February 1, 2018

**Re: Clean Air Task Force Initial Comments on Draft Accounting and Permanence Protocol for Carbon Capture and Geologic Sequestration under Low Carbon Fuel Standard**

Fig. 7. Comparison of model predictions and observations for pressure response at MW-2 (Copper Ridge dolomite) [8]

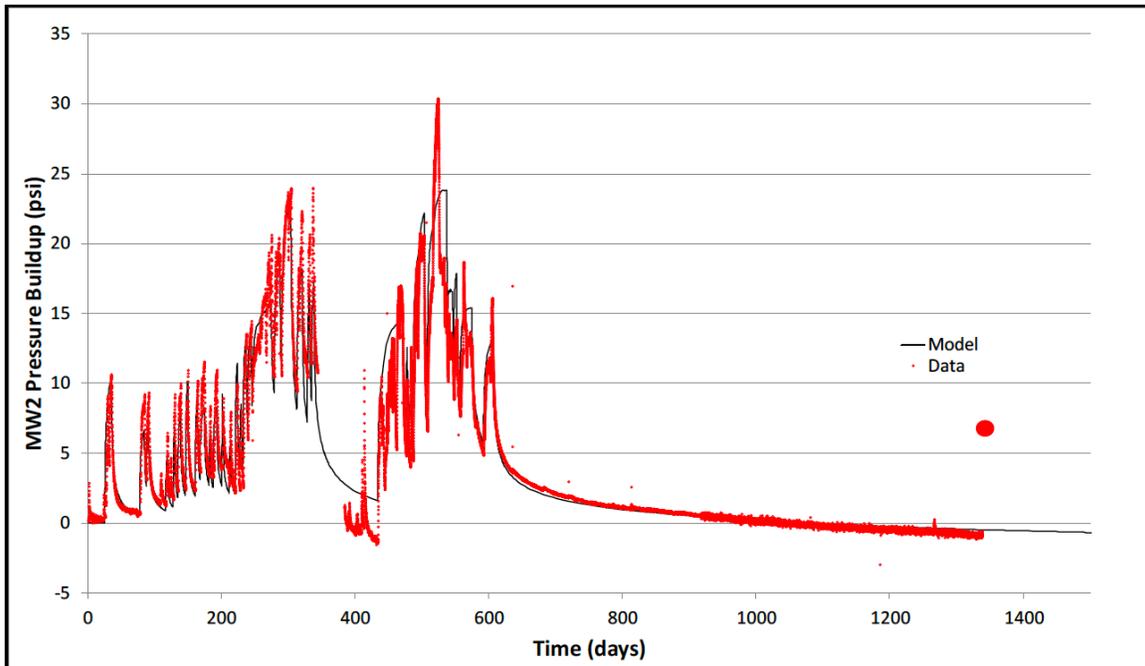
Pressure monitoring and modeling. The project also collected continuous downhole pressure, at five wells, and data from the injection reservoir in order to compare pre-injection formation pressure with post-injection formation pressure. This data demonstrated that the pressure front had stabilized and the CO<sub>2</sub> plume had stabilized - two of the three post-injection criterion. The data further showed that following the cessation of injection, that pressures decreased in both formations reached stable levels at +/- three psi (0.1 %) of initial reservoir pressure within about 3 years as documented in 2014. The deep pressure monitoring showed that there was hydraulic connectivity between the reservoirs and the results were consistent with the modeling for radial plume migration, thereby validating the model. During the post-injection monitoring, the pressure had declined and flat-lined to the initial formation pressure, matching the prediction of the model as illustrated in figure 7 from the paper, inserted in the text below.

In summary, the requirements and goals for post-injection site care were met at Mountaineer, and all obligations and regulatory requirements were fulfilled. the CO<sub>2</sub> plume was demonstrated as stable and there was no demonstrated endangerment to the USDW. This allowed the project to close after 3 years, well before the 20-year timeframe in the UIC permit.
